PRODUCT CHANGE NOTIFICATION

#PCN-ICC-BA8X-14

ST 10-TWIN series design change.

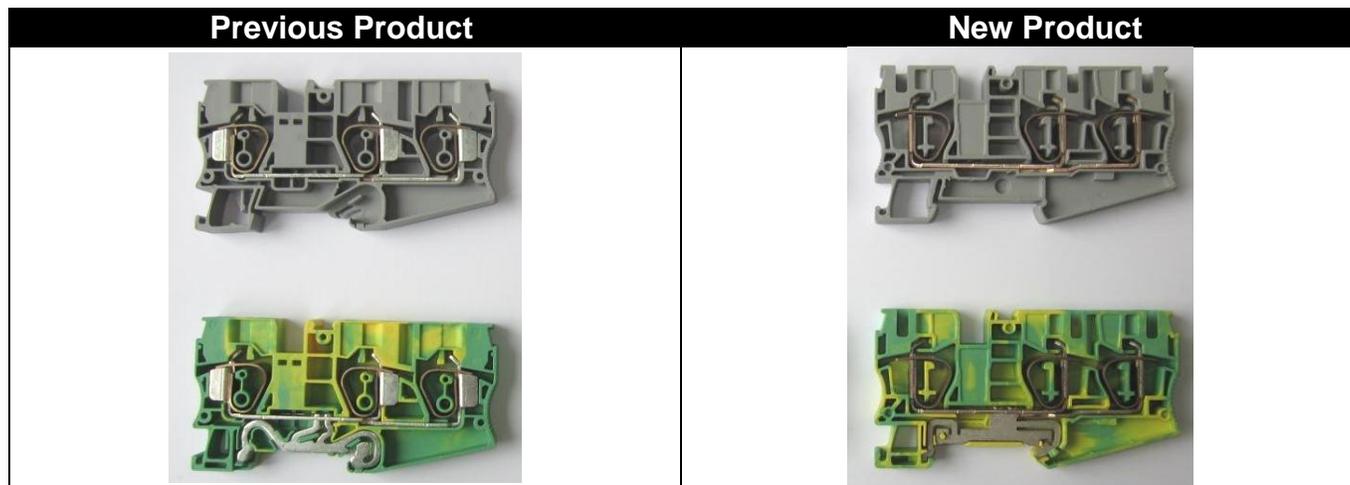
Expanded conductor funnels for standard solar cables up to 9mm outside diameter. The lengths of the new housings are 1.5mm shorter, so a new cover D-ST 10-TWIN batch V/C:01 is also needed.
 Same UL and CSA approvals as before.
